<b>Title - Sujet</b> CCGV P. Radisson - Refit 2020	
<b>Solicitation No. - N° de l'invitation</b> F3065-202250/A	<b>Amendment No. - N° modif.</b> 001
<b>Client Reference No. - N° de référence du client</b> F3065-202250	<b>Date</b> 2020-09-23
<b>GETS Reference No. - N° de référence de SEAG</b> PW-\$QCV-007-17988	
<b>File No. - N° de dossier</b> QCV-0-43087 (007)	<b>CCC No./N° CCC - FMS No./N° VME</b>
<b>Solicitation Closes - L'invitation prend fin</b> <b>at - à 02:00 PM</b> <b>on - le 2020-10-08</b>	<b>Time Zone</b> <b>Fuseau horaire</b> Heure Avancée de l'Est HAE
<b>F.O.B. - F.A.B.</b> Specified Herein - Précisé dans les présentes <b>Plant-Usine:</b> <input type="checkbox"/> <b>Destination:</b> <input type="checkbox"/> <b>Other-Autre:</b> <input checked="" type="checkbox"/>	
<b>Address Enquiries to: - Adresser toutes questions à:</b> Simoneau, Steve	<b>Buyer Id - Id de l'acheteur</b> qcv007
<b>Telephone No. - N° de téléphone</b> (418) 564-9517 ( )	<b>FAX No. - N° de FAX</b> (418) 648-2209

## NOTICE OF AMENDMENT 001

Figure 3: Transit block on top of multibeam ram

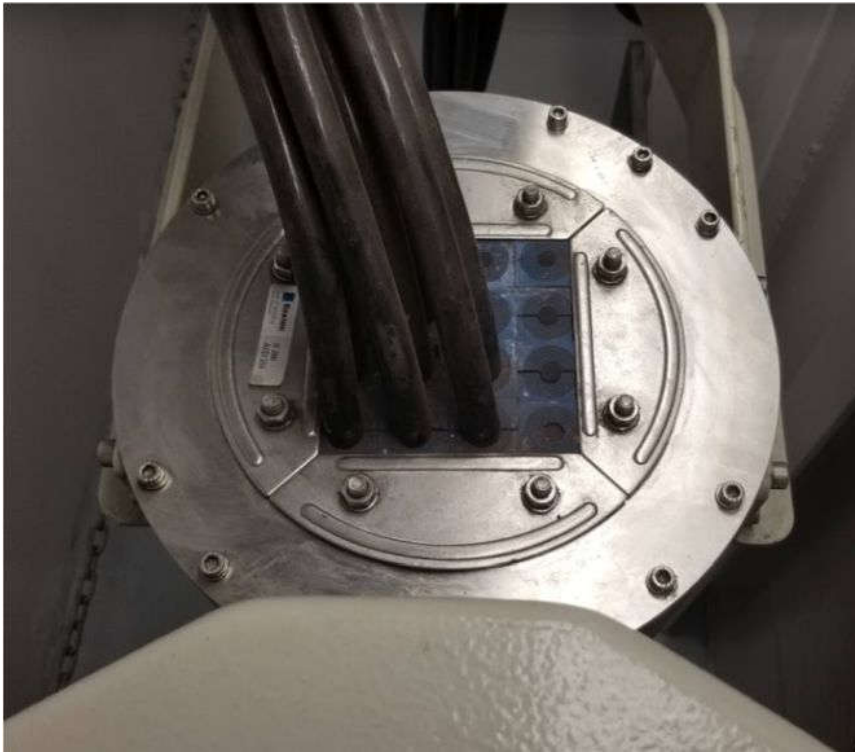
20.1.C.5.1 The Contractor must supply and install transit modules that are class approved and can be used in a Roptex System R150. All the modules must be changed for new modules.

20.1.C.5.2 The Contractor must re-pack the Roptex system as per manufacturer instructions.
